DFMPro analysis

For XYZ

Machining:
DFMPRO ANALYSIS

Deep Holes:

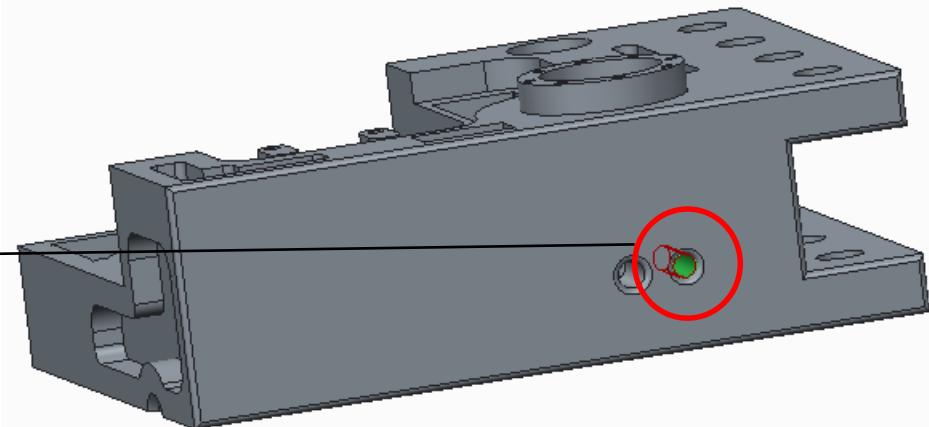
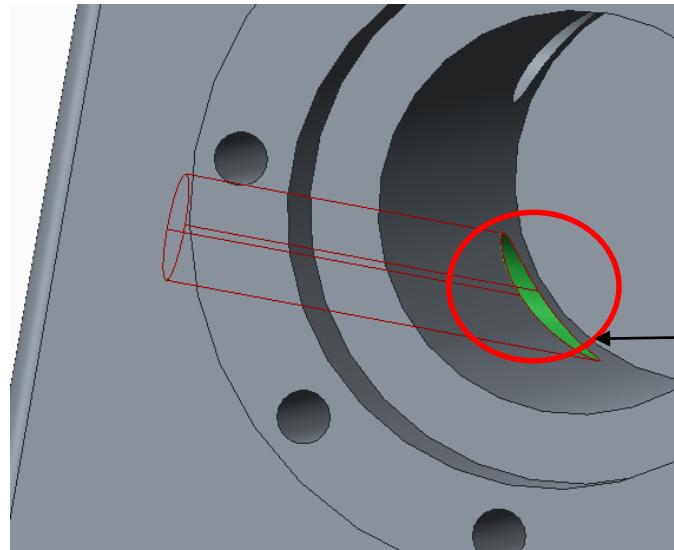
Explanation : Deep, small diameter holes are difficult to machine. Smaller diameter drills tend to wander and are prone to break, therefore, they are not recommended for convenient mass production. Chip removal becomes difficult while drilling deep holes.

Actual depth to diameter ratio: 10 mm

Recommended depth to diameter ratio: <8.0 mm

Recommendation: Try to avoid deep holes with small diameters.

Standard Hole sizes

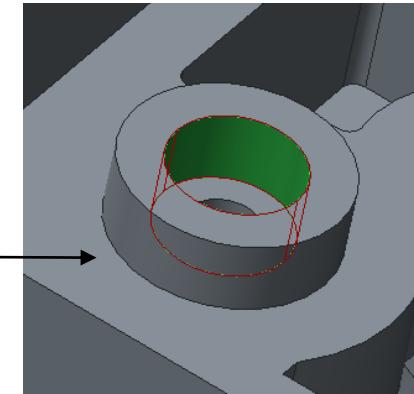
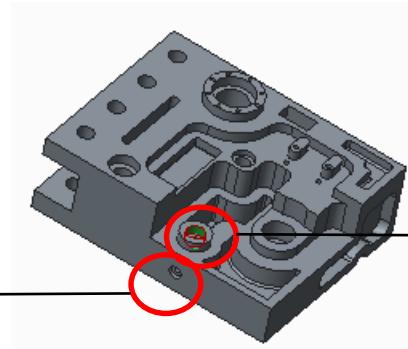
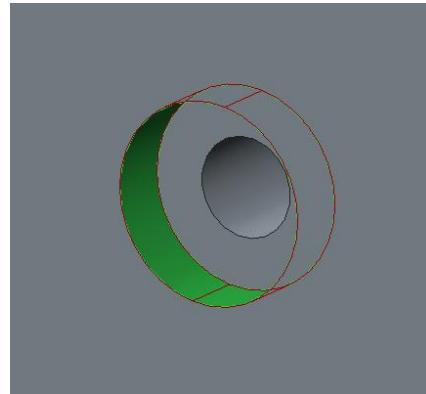
Explanation : Unusual hole sizes increase the cost of manufacturing through purchasing and inventory costs.

The diameter of this hole, 12.583 mm, is not a standard hole diameter. 12.5 mm and 12.8 mm are the nearest standard hole diameters.

The diameter of this hole, 18.028 mm, is not a standard hole diameter. 18.0 mm and 18.5 mm are the nearest standard hole diameters.

Recommendation: Try to use standard hole sizes which can be configured in the rule configuration window.

Recommended Rib Parameters

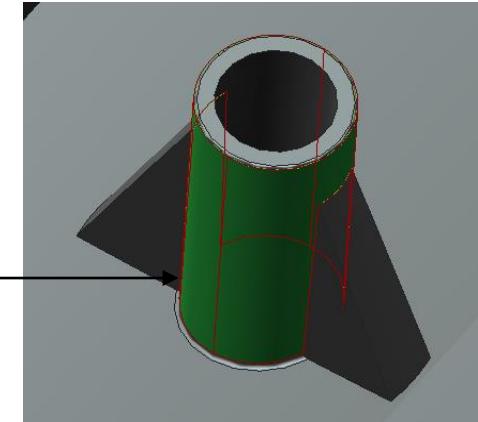
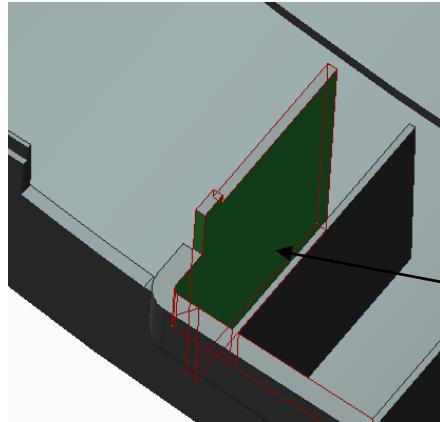
Rib thickness (3.481 mm) to nominal wall thickness (3.0 mm) ratio is 1.16 whereas it is recommended to be ≤ 0.4 (Recommended Rib thickness ≤ 1.2 mm).

Rib height (22.966 mm) to nominal wall thickness (3.0 mm) ratio is 7.655 whereas it is recommended to be ≤ 2.5 (Recommended Rib height ≤ 7.5 mm)

Rib thickness (3.697 mm) to nominal wall thickness (3.0 mm) ratio is 1.232 whereas it is recommended to be ≤ 0.4 (Recommended Rib thickness ≤ 1.2 mm).

Rib height (10.0 mm) to nominal wall thickness (3.0 mm) ratio is 3.333 whereas it is recommended to be ≤ 2.5 (Recommended Rib height ≤ 7.5 mm)

Recommendation: Generally, rib height is recommended to be not more than three times nominal wall thickness. Similarly, rib thickness at its base should be around 0.6 times nominal wall thickness.

Minimum radius at base of Boss:

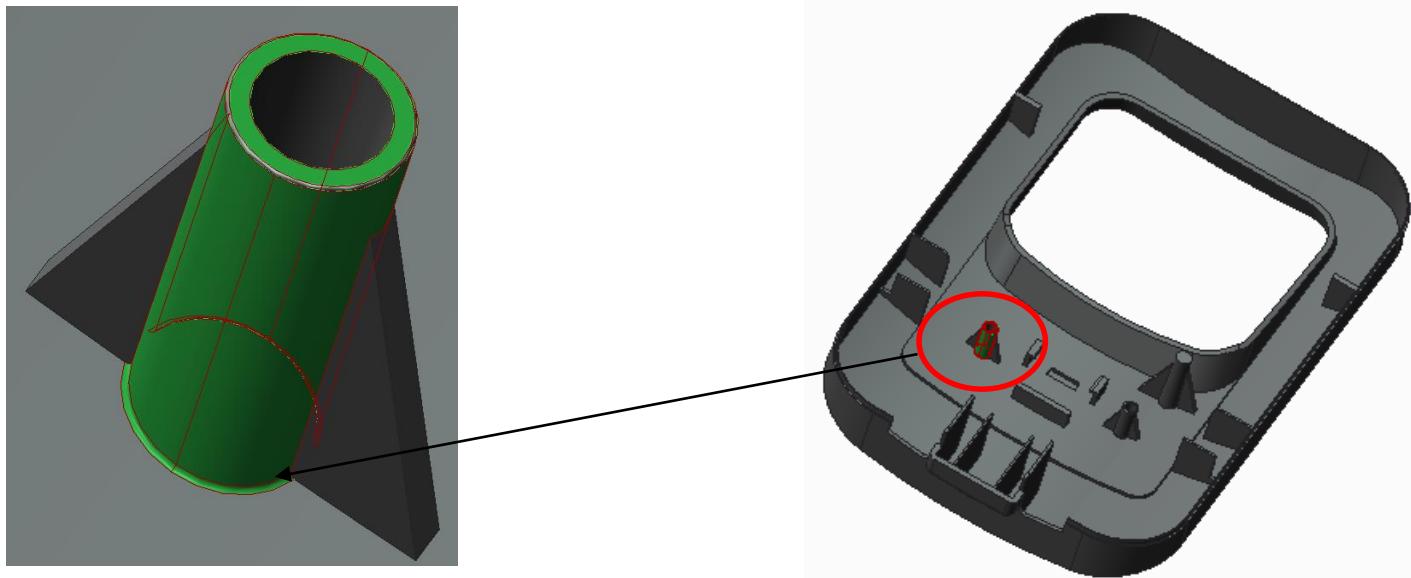
The radius at the base of boss is 0.25 mm which is 0.083 times the nominal wall thickness of the part, whereas it is recommended to be ≥ 0.75 mm i.e. 0.25 times the nominal wall thickness of the part. The nominal wall thickness of the part is 3.0 mm.

Recommendation: The suggested value for minimum required radius at the base of boss is 0.25 times nominal wall thickness.

Mold Wall Thickness

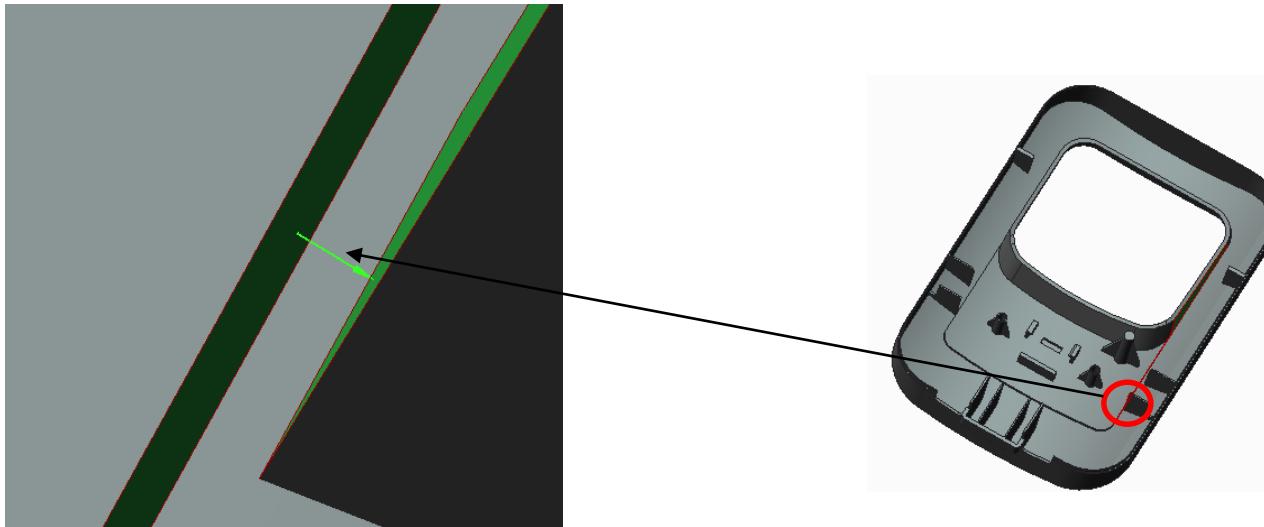
The Mold wall thickness is 0.319 mm which is 0.106 times the nominal wall thickness (3.0 mm) of the part whereas it is recommended to be ≥ 6.0 mm i.e. 2.0 times the nominal wall thickness of the part

Recommendation: Minimum allowable mold wall thickness needs to be decided based on process and material considerations. However it is normal to have clearances of 1 mm between features of an injection molded plastic part thus allowing a mold wall of that dimension.
